## State Planning Provisions Review 2022 - Submission 72

Submission No:	Name	Organisation
72	Sophie Underwood	Freycinet Action Network

**From:** [Sophie Underwood](#)  
**To:** [State Planning Office Your Say](#)  
**Subject:** State Planning Provisions (SPPs) Review - Scoping Issues – Scenic Protection Code  
**Date:** Friday, 12 August 2022 7:32:17 AM  
**Attachments:** [2020-08-25-GSBC Agenda-1.pdf](#)  
[2020-08-25-GSBC Minutes.pdf](#)  
[FAN Submission SPP Review Aug 2022.pdf](#)  
[Underwood and Ascui Representation GSB LPS Feb 2020.pdf](#)

# Notice of Meeting and Agenda

Figure 8 – Conservation covenanted properties 1 to 4.

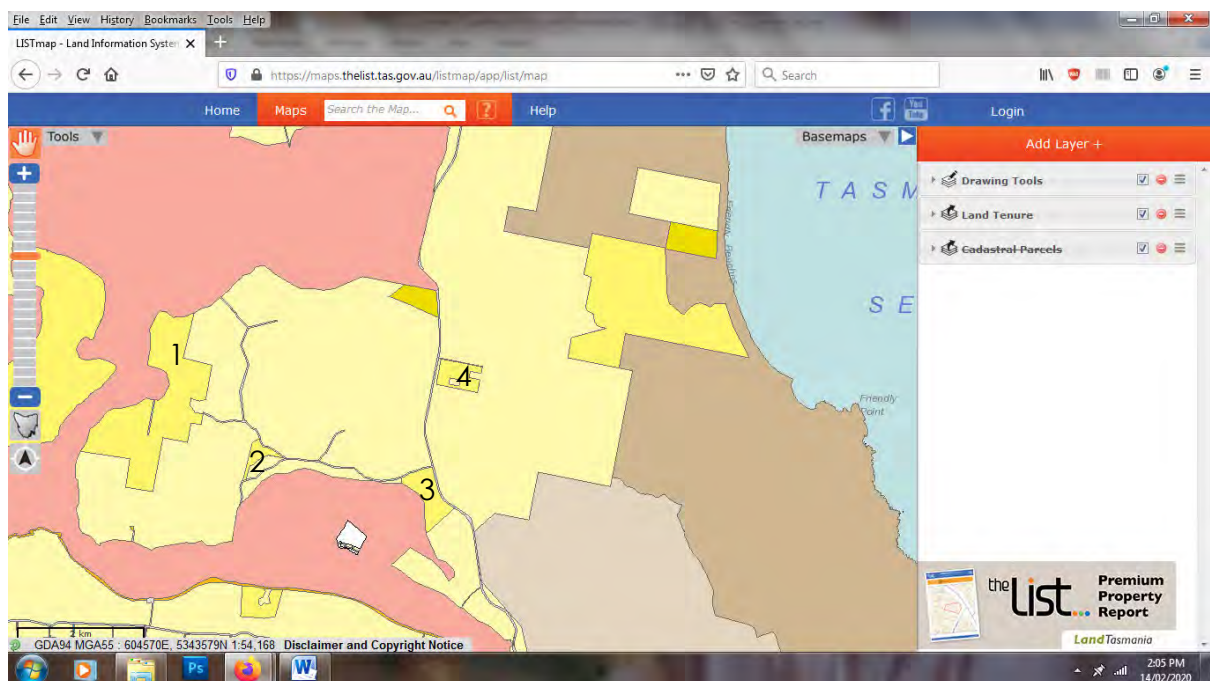
These are subject to conservation covenants and it is recommended that these properties be in the Landscape Conservation Zone.

Figure 9 – Conservation covenanted property 5.

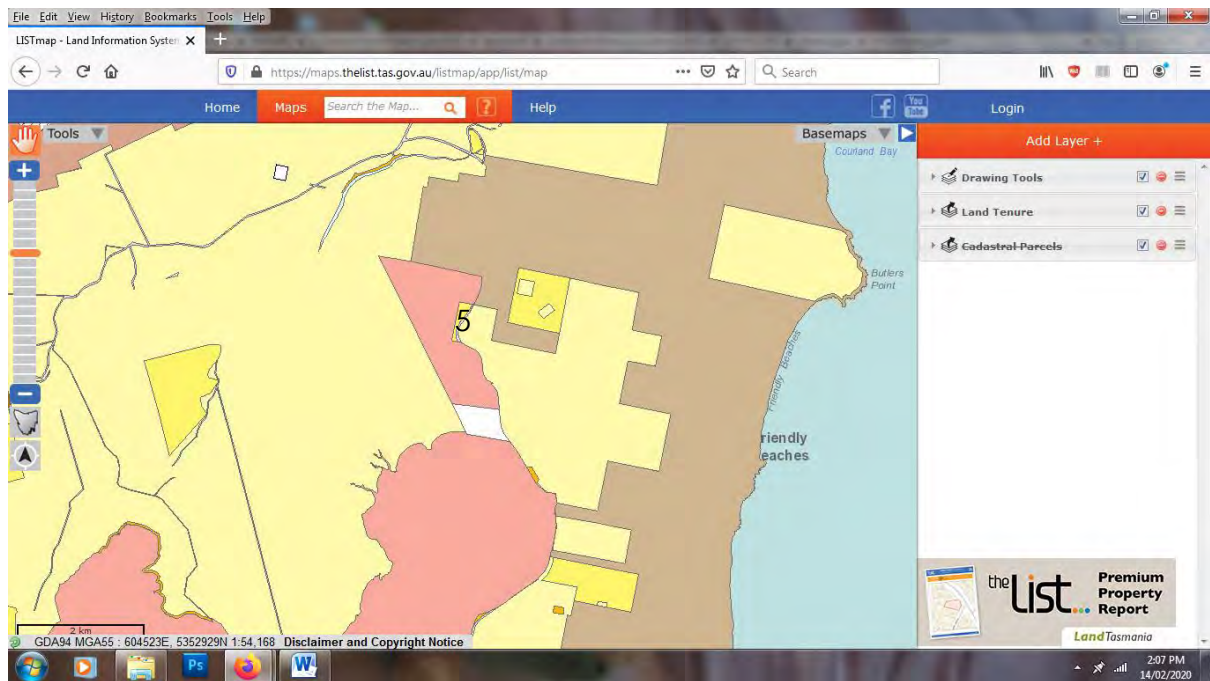
(note check title/covenant boundary over river)
